INSPECTOR'S REPORT ON A LICENCE APPLICATION

To:	Directors
From:	Brian Meaney - Environmental Licensing Programme
Date:	28 August 2013
RE:	Application for a Waste Licence Review from KMK Metals Recycling Ltd, Cappincur Ind. Estate, Daingean Road, Tullamore, Co. Offaly. Licence Register W0113-04.

Figure 4 The new E area as constructed with concrete surface throughout, clearly delineated site boundary and storage/process building at centre.

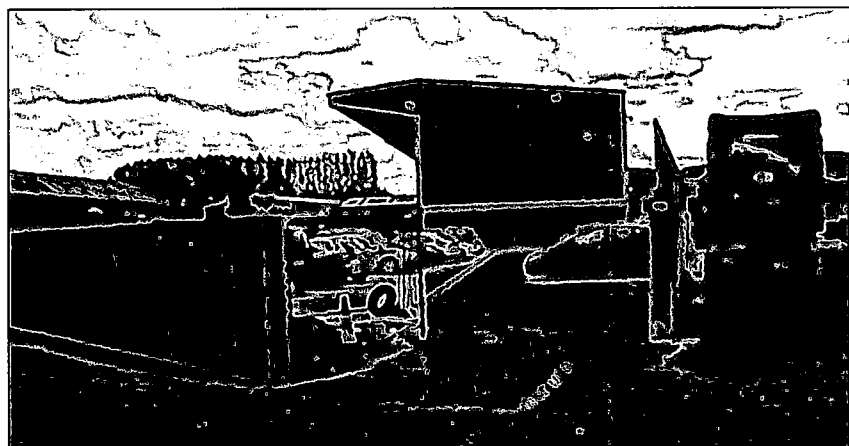
The new building in the E area will be used for additional storage and treatment capacity for WEEE. A new emission point to air is anticipated by the licensee in this area and this is discussed further in section 5.1 below. The E yard area has been constructed with concrete hardstanding and drainage to a new storm water attenuation tank and interceptor.

Figure 5 Two of three storm water outflows to the land drain (which is approximately 1.4m wide) running outside of and along the site boundary on two sides. The new storm water outflow “E” will discharge to the same land drain a short distance away.

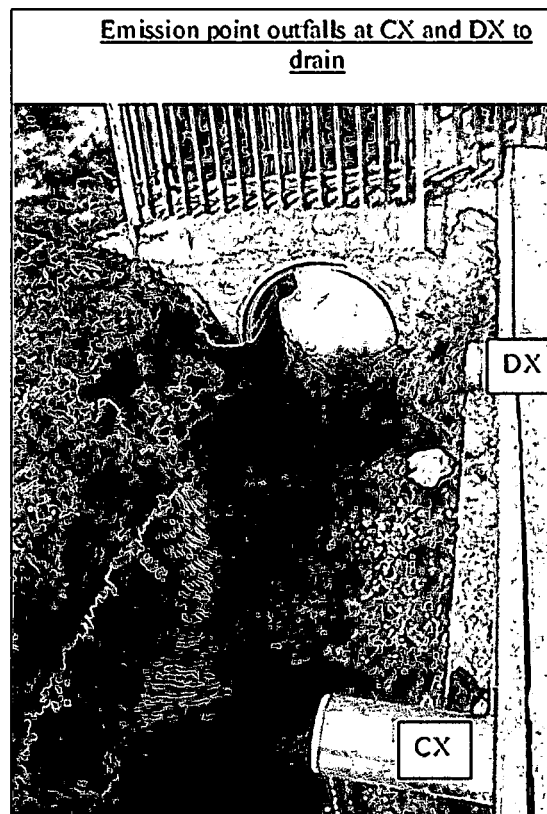
Monitoring data for the discharges from CX and DX (serving the A/B/C and D areas respectively) in the AERs for 2010 and 2011 were considered in the context of the environmental quality standards in the European Communities Environmental Objectives (Surface Waters) Regulations 2009. Certain parameters (including ammonia, zinc, chromium, nickel and lead) in the discharges from CX or DX occasionally exceed environmental quality standards that are applicable to surface water bodies. Other parameters such as suspended solids and COD were high on several occasions in 2010 and 2011 (maximum 440mg/l and 302mg/l for suspended solids and COD respectively). Mineral oil and diesel range organics have also been detected in discharges from the yard areas.

The sources of these pollutants in the discharges at CX and DX are likely to be dust or other run-off from yard areas, including residues from WEEE stored outdoors being washed onto drained surfaces within the facility. Certain instances of high readings are attributed by the licensee, at least in part, to deficiencies in interceptor operation and to construction activities ongoing during these periods.

Given the periodic occurrence of high readings for mineral oil in storm water discharges from the facility in the period 2008-2011, it is proposed in **Schedule B.2** of the RD that an emission limit value (as opposed to a trigger level) of 2mg/l is imposed at the three emission points, CX, DX and E. It is also appropriate that an emission limit value is imposed for suspended solids there being no equivalent environmental quality standard. The removal of these two pollutants is the objective of the silt traps and oil interceptors required under **condition 3.15** of the RD.
